PCN#	PCN20251121-011	PCN ISSUE DATE	Nov 21, 2025
PCN TITLE SKU#104991005, TRMNL 7.5" (OG) DIY Kit			
REVISION		CUSTOMER CONTACT	
TYPE OF CHANGE			
<input checked="" type="checkbox"/> Electrical Specification <input type="checkbox"/> Part Number <input type="checkbox"/> Mechanical Specification <input type="checkbox"/> End of Life <input type="checkbox"/> Firmware Specification <input type="checkbox"/> Other <input type="checkbox"/> Regulatory of Compliance			
AFFECTED PART NUMBER(S)			
Part Number	Name		
104991005	TRMNL 7.5" (OG) DIY Kit		
CHANGE DESCRIPTION			
The power management IC updated: From ETA6003 to SY6974B.			
Change FROM:			
Part Number	Name	Image	
104991005	TRMNL 7.5" (OG) DIY Kit

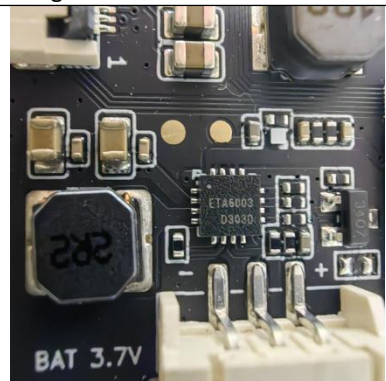
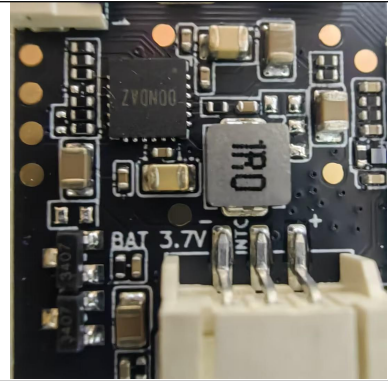
Change TO:		
Part Number	Name	Image
104991005	TRMNL 7.5" (OG) DIY Kit	
REASONS FOR CHANGE To achieve superior performance and user experience, the power management IC is being upgraded from ETA6003 to SY6974B . This replacement implements a more advanced power architecture, which requires minor circuit adjustments but maintains full functional compatibility.		
CUSTOMER ACTION REQUIRED Please switch to the alternative product.
